MEETING:	PLANNING AND REGULATORY COMMITTEE
DATE:	5 AUGUST 2020
TITLE OF REPORT:	200755 - PROPOSED ATTENUATION POND AS PART OF THE PROPOSED SURFACE WATER MANAGEMENT STRATEGY FOR EXTENT PLANNING PERMISSION REF 163707 FOR 15 HOUSES ON ADJOINING LAND AT LAND OPPOSITE MILL HOUSE FARM, FOWNHOPE, HEREFORDSHIRE For: S C Hardwick & Sons per James Spreckley MRICS, Brinsop House, Brinsop, Hereford, Herefordshire HR4 7AS
WEBSITE LINK:	https://www.herefordshire.gov.uk/info/200142/planning_services/planning_application_search/details?id=200755&search-term=200755
Reason Application submitted to Committee – Member application

Extract of Drainage Plan (with extant housing development layout shown)

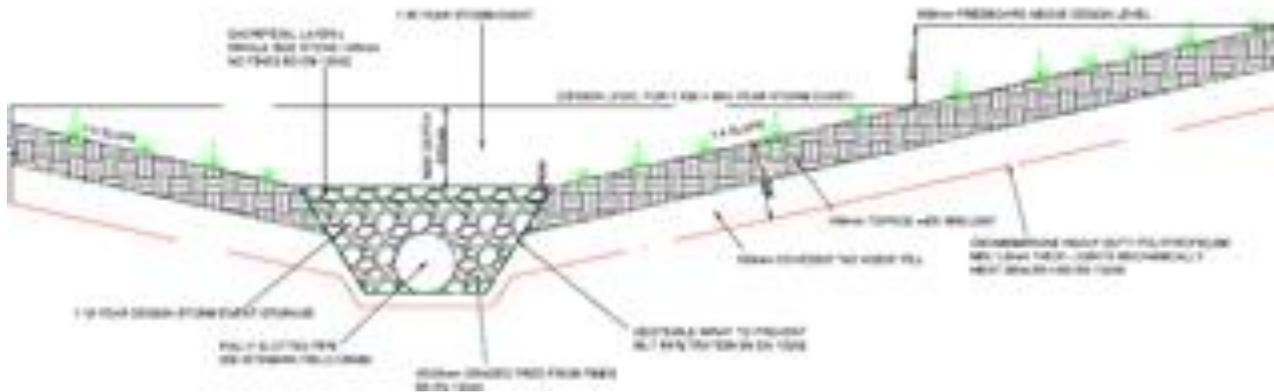
We have reviewed the information submitted as part of this application with particular focus on drawing number S649/02 which shows the location of the proposed attenuation pond. Our record of public assets indicates the presence of a 180mm public watermain and 100mm non operational watermain. It is unclear whether these have been accurately located and if the required easement of 3 meters either side can be maintained. We therefore request further investigations and clarity on this matter.

Please update the drawing to show the full extent of the regraded area around the pond. The cross section shows the extent of land that will need to be re-contoured but this is not shown on the plan view. This should demonstrate how far the inclined ground is from the road carriageway. We note that water will be retained above the carriageway.

We note that the 300mm pipes and any respective manholes below the pond are not shown, presumably to avoid cluttering the drawing. From past discussions with Welsh Water, we understood that they were willing to adopt perforated drains below balancing ponds that are designed for cleansing. The standard detail that received in July 2019 showed a single pipe, not multiple pipes. We request that the applicant presents correspondence with Welsh Water demonstrating that the proposed design meets with their requirements.

We note that the microdrainage calculations show a 525mm dia pipes laid with a gradient of 1/500. These will not meet self cleansing criteria. We request clarification that Welsh Water have approved the proposals for two parallel pipes, normally parallel pipes are installed staggered to help prevent siltation.

The base of the pond is shown as 51.25 m AOD on the drawing. The 30 year design calcs show the top water level as 51.77m AOD. For welsh water to adopt the system the top water level would need to be at or below 51.25m AOD.

Please update the drawing to show the full extent of the regraded area around the pond. The cross section shows the extent of land that will need to be re-contoured but this is not shown on the plan view. This should demonstrate how far the inclined ground is from the road carriageway. We note that water will be retained above the carriageway.

We note that the 300mm pipes and any respective manholes below the pond are not shown, presumably to avoid cluttering the drawing. From past discussions with Welsh Water, we understood that they were willing to adopt perforated drains below balancing ponds that are designed for cleansing. The standard detail that received in July 2019 showed a single pipe, not multiple pipes. We request that the applicant presents correspondence with Welsh Water demonstrating that the proposed design meets with their requirements

We note that the microdrainage calculations show a 525mm dia pipes laid with a gradient of 1/500. These will not meet self cleansing criteria. We request clarification that Welsh Water have approved the proposals for two parallel pipes, normally parallel pipes are installed staggered to help prevent siltation

The applicant has suggested that the flow rate will achieve self cleansing velocity. In reality this could only occur during a storm. This feature is not shown on the Welsh Water standard detail.

The base of the pond is shown as 51.25 m AOD on the drawing. The 30 year design calcs show the top water level as 51.77m AOD. For Welsh Water to adopt the system the top water level would need to be at or below 51.25m AOD

- No information is provided about its setting in relation to the new houses or the orchard land that will be lost.
- No boundary treatment or new hedgerow is discussed.
- A label on the drawing (S649/02) states that the existing access is to be improved, however no details are given in relation to whether this means a new gate, widening or hedgerow loss to improve visibility.

Based on the plan there appears to be sufficient space along the edge of the road carriageway.
